**ZONING AMENDMENT
PLANNED UNIT DEVELOPMENT &
SUBDIVISION STAFF REPORT**

<u>NAME</u>	Jane Conkin
<u>DEVELOPMENT NAME</u>	The Townhomes of Batre Lane Subdivision
<u>LOCATION</u>	West side of Batre Lane, extending from the North side of Old Shell Road to the South side of Gaillard Street
<u>PRESENT ZONING</u>	R-1, Single-Family Residential
<u>PROPOSED ZONING</u>	R-2, Two-Family Residential
<u>AREA OF PROPERTY</u>	3 Lots / .9+ Acres
<u>CONTEMPLATED USE</u>	Three, two-unit townhomes on three lots, with shared parking and access It should be noted, however, that any use permitted in the proposed district would be allowed at this location if the zoning is changed. Furthermore, the Planning Commission may consider zoning classifications other than that sought by the applicant for this property.
<u>TIME SCHEDULE FOR DEVELOPMENT</u>	Immediately
<u>ENGINEERING COMMENTS</u>	Must comply with all stormwater and flood control ordinances. Any work performed in the right of way will require a right of way permit.

SITE PLAN

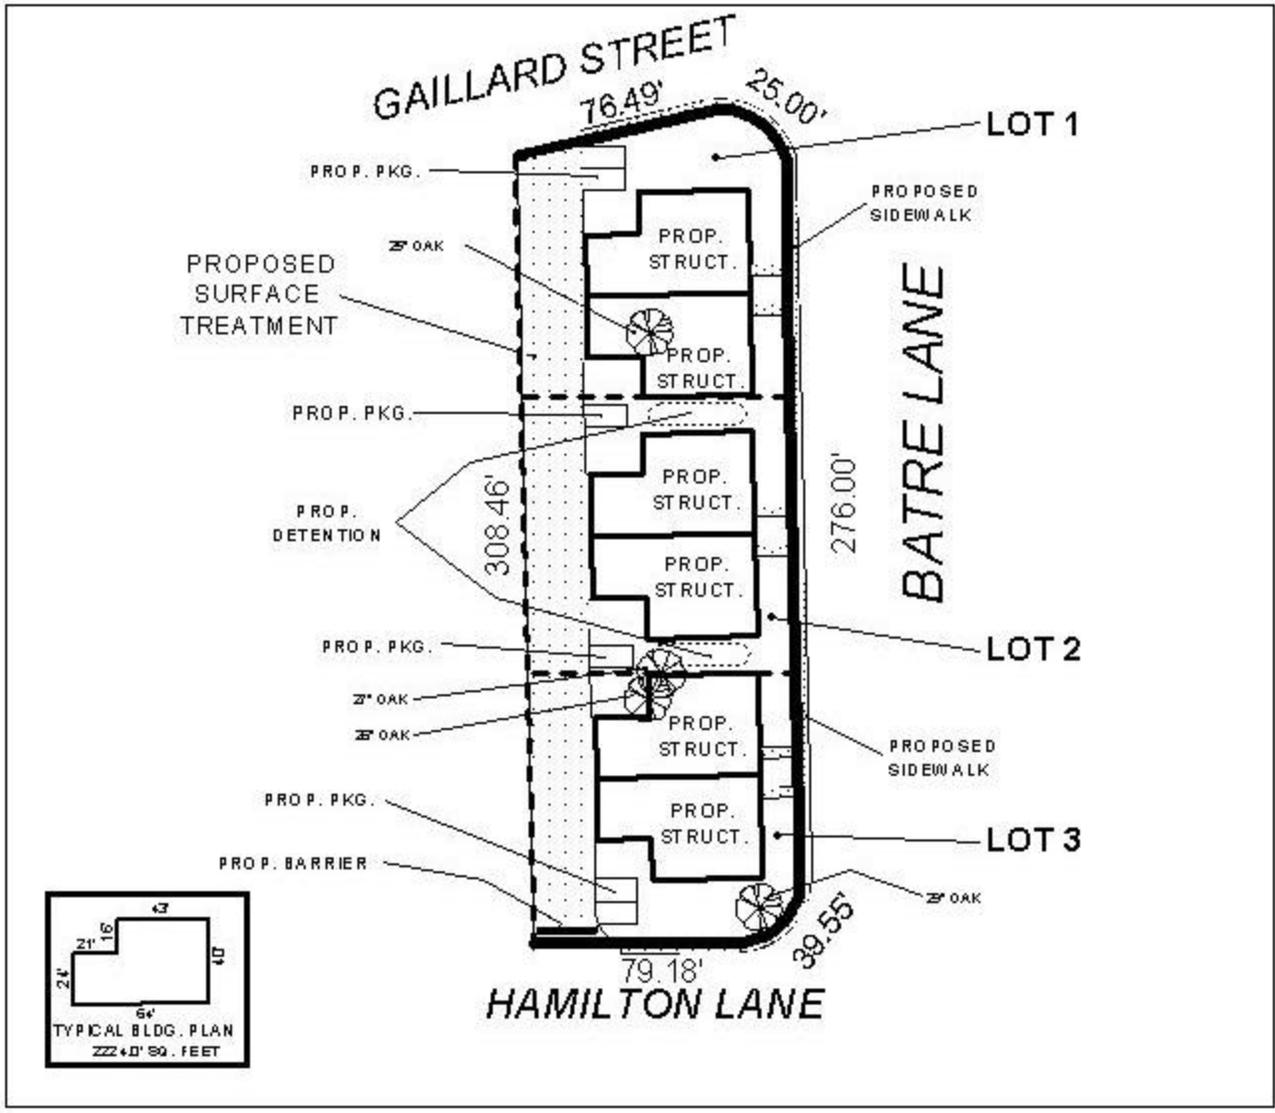
As illustrated on the site plan, the six units and guest parking would access Gaillard Street. Gaillard Street is a minor residential street with substandard improvements—the pavement is only 16-foot wide, less than the standard driveway width for two-way traffic in a parking lot. Gaillard Street also serves as the only access for six existing homes to the West, and the approval of six dwelling units on this site would essentially double traffic on the substandard street. As outlined above, PUD approval requires that adequate

access be provided without generating excess traffic along minor residential streets; Gaillard is a minor street.

The applicant is also requesting a reduced front setback of 15-feet. Although reduced front setback requests are frequently granted, the reduced setback is typically within a homogenous development, not on a single block frontage within an existing neighborhood. The PUD Section of the Zoning Ordinance permits “flexibility in the location and arrangement of buildings” and encourages innovative and diversified building design. However, the PUD Section stipulates, “the tract of land to be occupied by the PUD shall be of sufficient size to accommodate the proposed uses and buildings in a homogeneous and harmonious entity (as distinguished from typical lot-by-lot development).”

Planned Unit Development: Based upon the preceding, this application is recommended for denial.
